Technical Bulletin / Safety Alert

Unique ID No: TBS2013-TBSA-01

Subject: JUG-A-0 Unplanned Movement - Incident Notification

Date: 19th September 2013

Drawn WJO	Date 03.09.13	Checked D.C.	Approved L.M.	Date 27.09.13	Section 0314 HYDRAULIC SCHEMATICS
					Title JUG-A-0 UL/UV TRANSMISSION CIRCUIT
					Part No. 0314-005

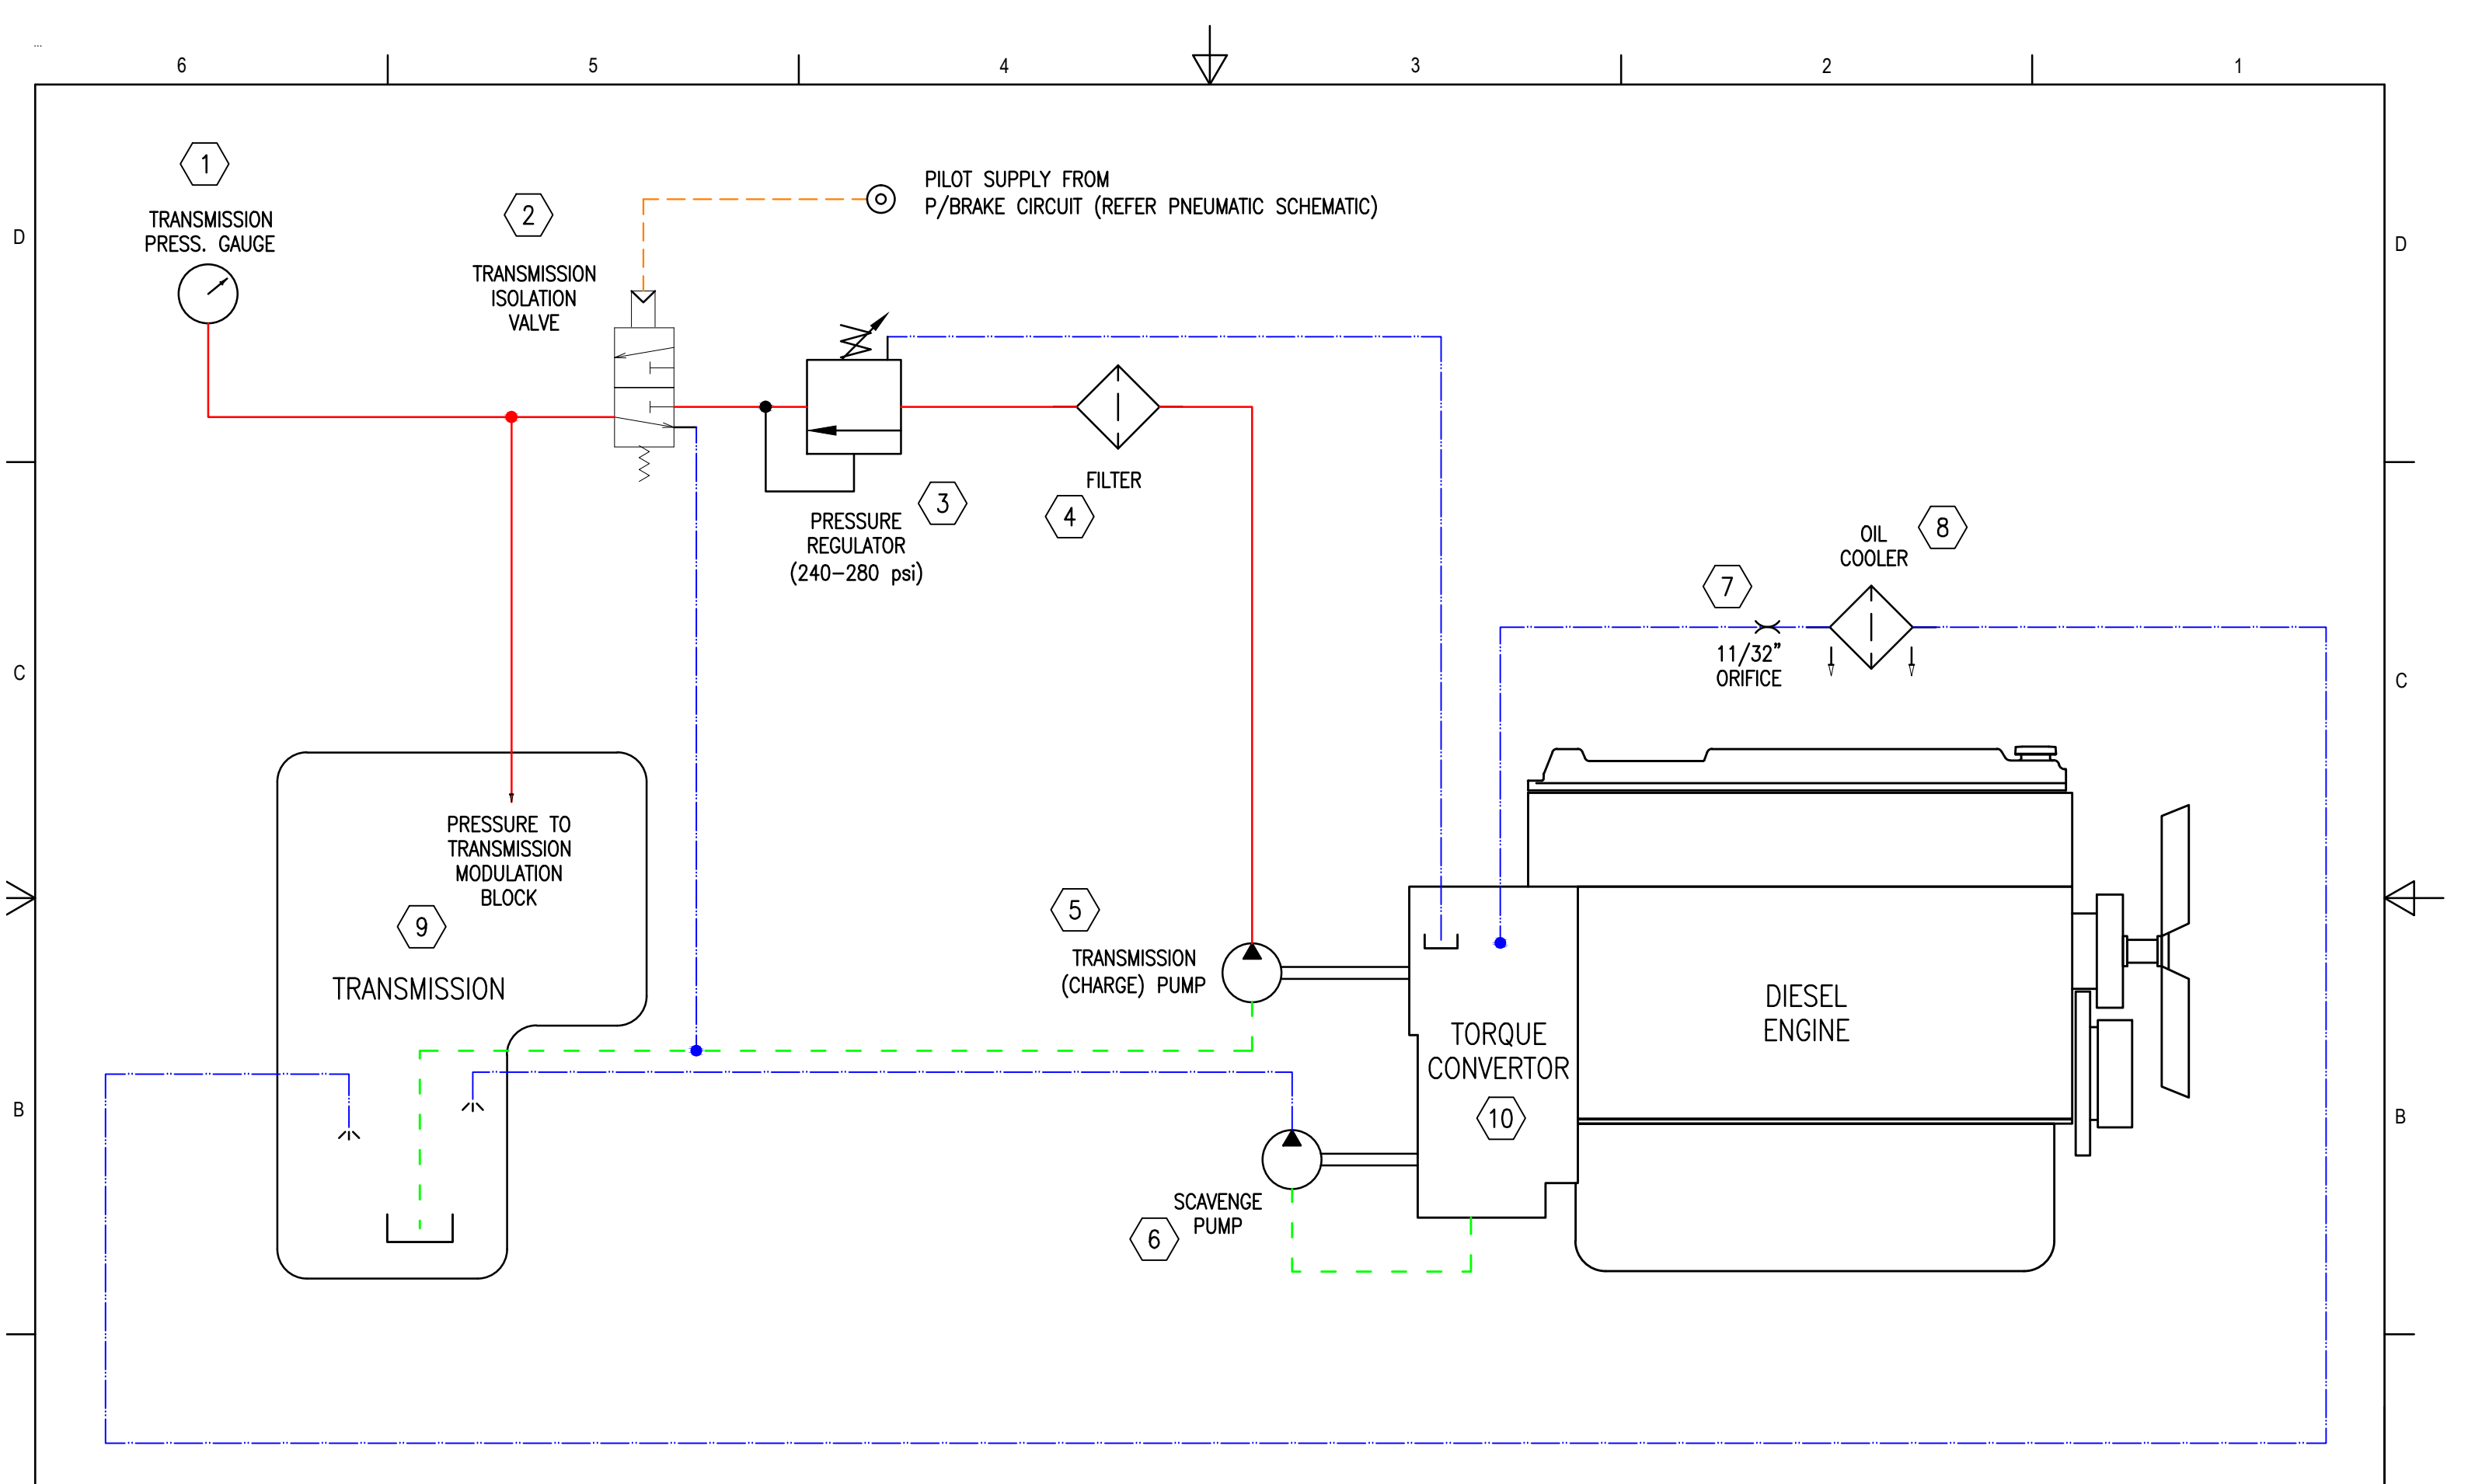
VLI originally intended to engineer a transmission isolation valve as an alternative to the transmission de-clutch cylinder. This valve would be air piloted from the park brake circuit to prevent hydraulic oil supply to the transmission control valve on park brake activation, thus isolating the transmission from gear engagement whenever the park brake is applied.

After the transmission isolation valve was installed and functionally tested, a failure modes affects analysis (FMEA) was completed , which highlighted that simply replacing the de-clutch cylinder (and associated pilot valve) with an isolation valve did not provide a greater level of functional safety or allow for isolation valve redundancy.

VLI have concluded that the current de-clutch function should be retained and that a transmission isolation valve be included in the transmission hydraulic circuit as an additional means of transmission isolation. This arrangement also provides redundancy for both the de-clutch valve and the transmission isolation valve.

The addition of the transmission isolation valve to the transmission hydraulic circuit is an additional layer of protection to the existing equipment design.

VLI recommends all equipment owners and end users consider upgrading their JUG-A-0 UL/UV vehicles to include the transmission isolation valve at the next major service interval. Revised parts pages and circuit drawings will be supplied with upgrade components.
